# Proposed Changes for SPI-4

00-246r3

Paul Aloisi TI

The driver/receiver electrical changes proposed for SPI-4

Fast-160 LL Receiver Mask for isolated assertion or negations, during the data transitions +/-1.1 volt maximum with reflections

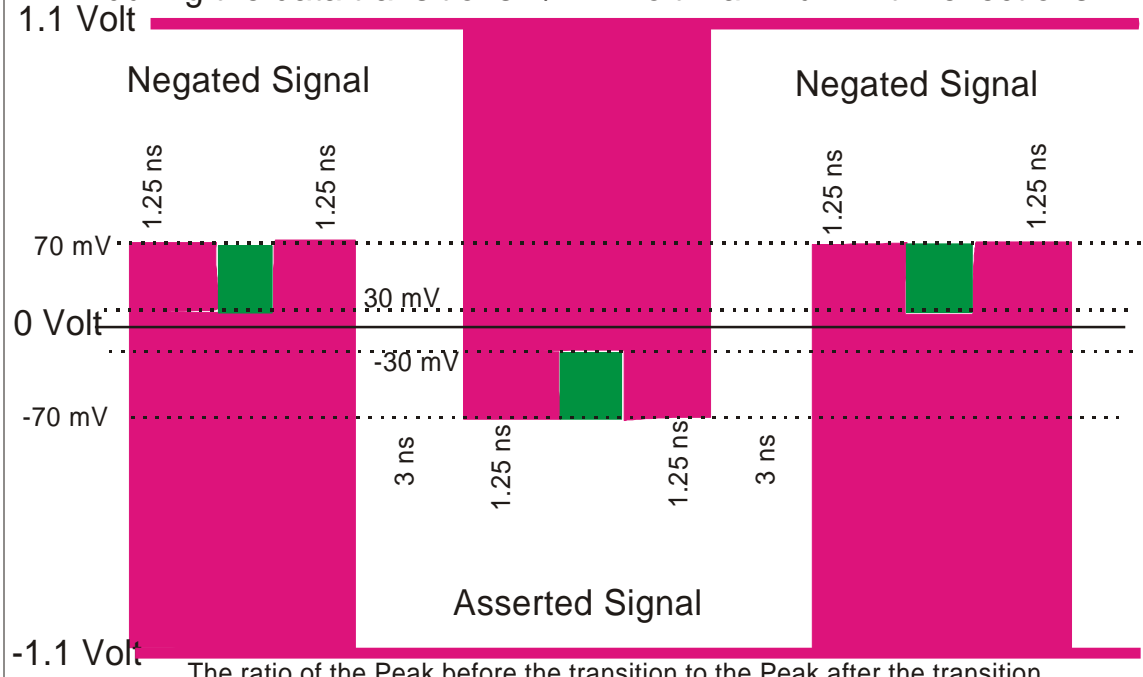
Figure 51 and 52 Receiver Mask paced data transfer needs to be different for the 3 camps, there should be 3 new masks

The ratio of the Peak before the transition to the Peak after the transition in the 1.25 ns range shall not exceed 4 to 1.
